S E R V I C E N O T E

3070 Board Test Systems**Serial Numbers:** 0000A00000 / 9999Z99999**Temporary Double Density Pin Card Support Strategy****Situation:**

DATE: May 1999

FIGURE 1 - Physical Location of Identifiers

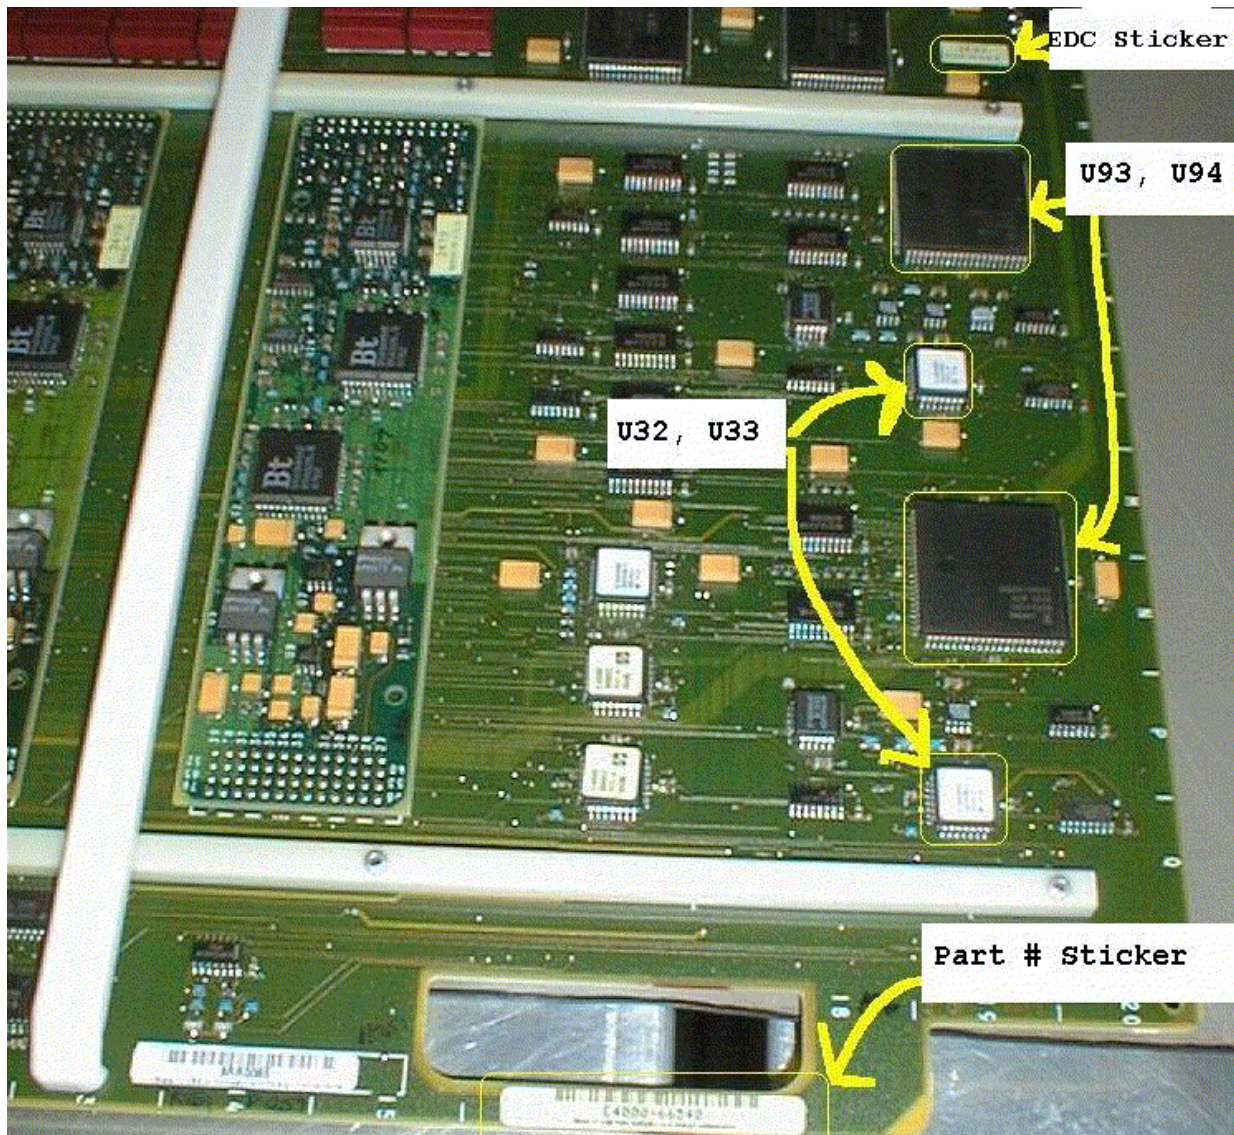
The E4000-66580 and E4000-66586 cards can be identified by the following:

1. The E4000-66580 and E4000-66586 part number is located on the sticker near the handle of the card.
2. The U93 and U94 chips are AMI manufactured chips.
3. The U32 and U33 chips are part number E4000-88808.
4. The Engineering Date Code (EDC) is 3905.

See Figure 1 at the end of this Service Note for physical locations of the part number sticker, the chips and the EDC sticker on the boards.
